Subject: Fuel Leak Case No. RO0002440 and Geotracker Global ID T0600148042, Bernard's Gas, 1051 Airway Blvd., Livermore, CA 94550

Alameda County Environmental Health (ACEH) staff has reviewed the fuel leak case file for the above-referenced site including the recently submitted document entitled, "Soil and Groundwater Investigation Report," dated March 28, 2007 and prepared on your behalf by Closure Solutions, Inc. The Soil and Groundwater Investigation Report presents the results from a soil and groundwater investigation that included one soil boring and installation of five monitoring wells. Two additional proposed wells were not installed due to the presence of utilities in the median of Airway Boulevard.

Subject: Fuel Leak Case No. RO0002440, Bernard's Gas, 1051 Airway Blvd., Livermore, CA - Work Plan Approval

Attachment 1: Revised Figure 2 - Site Plan Map

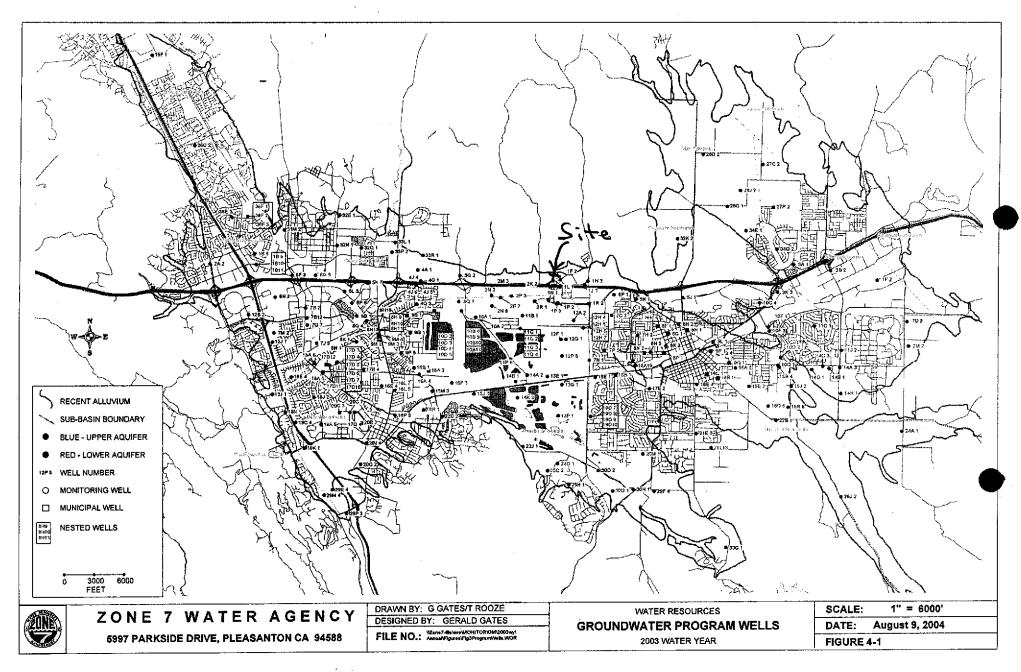
- Proposed Well Locations. On the attached figure, please see the suggested revisions to the proposed monitoring well locations. ACEH also requests that an additional shallow monitoring well be installed adjacent to the proposed deep monitoring well, MW-5.
